INDESIT company

Model type:
AVSL105EU

Commercial code:
F029992

n1040325: New shock absorber fixing system with pin

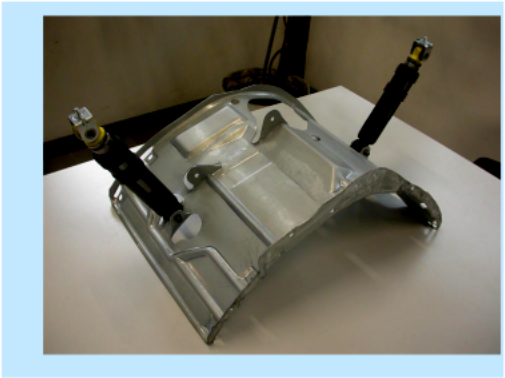
From serial no. 40427.0001, shock absorbers have been fixed to the tank unit cradle with two 11 mm pins code C00110163 (see fig. 01 and 02 enclosed) in place of the 8 mm screws code 093750 and relevant locking nuts code 030443, on all washing

machines and dryers produced in the Comunanza factory.
The items affected by this modification are:
1) The cradles have the same Service code, as they can be used in place of the new ones after widening the shock absorber fixing holes to a diameter of 10 mm.
Code 093848 - Tank unit cradle 46 lt
Code 093878 - Tank unit cradle 40 lt.
2) The new shock absorbers, with fixing bushing having no s/steel spacer, are not managed as they are interchangeable with the premodified items (make sure they are CIMA type, as the managed items), fixed with M8 screws code 093750 and related locking nut code 030443 (see figs. 05 and 06).
Code 093884 - Shock absorber 80 N
Code 093885 - Shock absorber 100 N

To remove the shock absorber from the tank, first extract the pin with a few hammer taps (see fig.03) until it is aligned with the tank bracket and then pull it out with a pair of pliers (see fig. 04).
(To refit the shock absorber use a new pin. Insert the pin until the toroidal edge is aligned with the bracket.)

n1040326: Two-bearing mechanism on Slim range washing machines

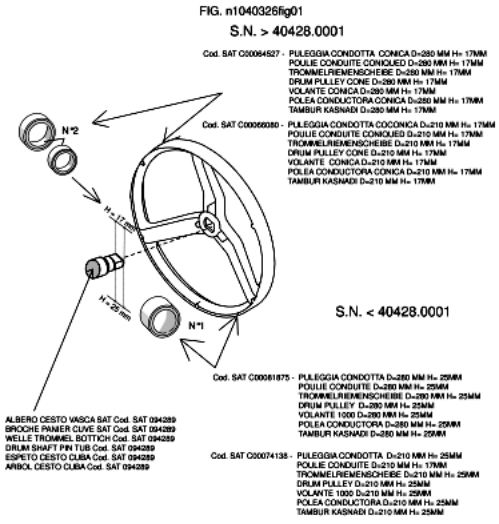
From serial no. 40428.0001, all Slim range models produced in the Comunanza factory have been equipped with a two-bearing mechanism in place of the single-bearing one.

The Service codes of the new mechanism are:
Service code C00096186 - SEAL RING CV4;
Service code C00002591 - BEARING 20X47X14 6204 SKF;
Service code C00013563 - BEARING 25 X52 X 15 6205 - 2Z SKF;
Service code C00110340 - CROSS WITH SEAL RING (2C) SNELLA;
Service code C00094289 - EVO 40L TANK SLIM (1-C) > (2-C)EVOII;
Service code C00094290 - OUTER- SET 40 L.(1-C)>(2-C)EVOII;
Service code C00064527 - DRIVEN PULLEY CONE D=280 MM H= 17MM;
Service code C00066080 - DRIVEN PULLEY CONE D= 210 MM H=17 MM.

The tank assembly with the new two-bearing cross has the same Service code as the single-bearing one (C00094289); the latter will be available until stocks run out.
When replacing the tank, make sure that the value H (17 mm or 25 mm) of the basket cross shaft corresponds to the value H of the pulley (see Fig.001).

Fig. n10402231

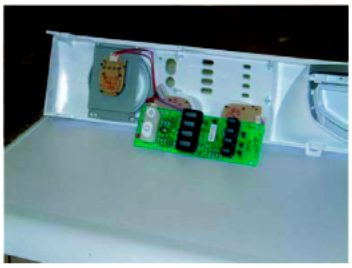
From serial no. 40429.0001, models AVL, AVXL, AVSL, AML have been equipped with a new panel with well holes for the ON/OFF and RESET buttons and flush plastic light diffusers in place of the projecting siliconed ones (see picture n10402231 Fig.02). These features determine whether an appliance is modified or premodification.
The modification has also involved the electronic card whose panel and display communication connectors are on the left and not at the back (see picture n10402232 Fig.2).

Fig . 001

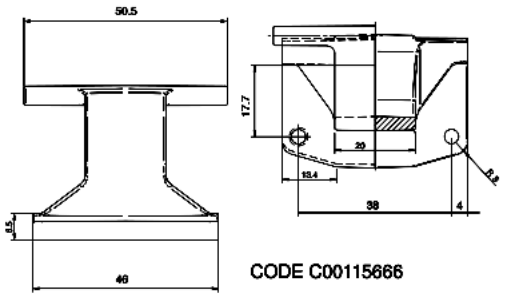
From serial no. 50207.0001, all Ariston models produced in the Teverola factory (see table 001 attached) with industrial code (given on the rating plate) starting with 46, have been equipped with a Zamac hinge with 150° opening angle, code C00115666 (see Fig.001).
This modification has involved the introduction of the following items:

Code C00115670 - Complete door EVOII 150° white 27 with standard glass;
Code C00115674 - Complete door EVOII 150° white 27 with long glass;
Code C00115667 - EVOII body for 150° hinge white 27;

The premodified items are not interchangeable separately with the modified ones.

Code C00110133 - Complete door EVOII Standard 180° white 27 standard glass;
Code C00092157 - Complete door EVOII 180° white 27 long glass;
Code C00096193 - EVOII body for 150° hinge white 27;

Fig . 001

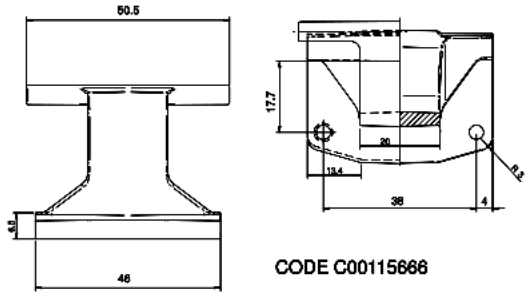
From serial no. 50207.0001, all Ariston models produced in the Comunanza factory (see table 001 attached) with industrial code (given on the rating plate) starting with 80, have been equipped with a Zamac hinge with 150° opening angle, code C00115666

(see Fig.001).
This modification has involved the introduction of the following items:

Code C00115670 - Complete door EVOII 150° white 27 with standard glass;
Code C00115674 - Complete door EVOII 150° white 27 with long glass;
Code C00115668 - Complete door EVOII 150° silver with standard glass;
Code C00115673 - Complete door EVOII 150° silver snella standard glass;
Code C00115662 - EVOII body for 150° hinge white 27
Code C00115663 - EVOII body for 150° hinge silver 27
Code C00115664 - Snella EVOII body for 150° hinge white 27
Code C00115665 - Snella EVOII body for 150° hinge silver

The premodified items are not interchangeable separately with the modified ones.

Code C00096416 - Complete door EVOII LB 180° standard depth silver;
Code C00097374 - Complete door EVOII 180° WD 180° white 27 long glass;
Code C00110133 - Complete door EVOII Standard 180° white 27
Code C00110178 - Complete door EVOII Snella 180° Silver;
Code C00091836 - EVOII body white 27 for 180° hinge;
Code C00094306 - EVOII body silver for 180° hinge;
Code C00094305 - Snella EVOII body white 27 for 180° hinge;
Code C00094307 - Snella EVOII body silver for 180° hinge;
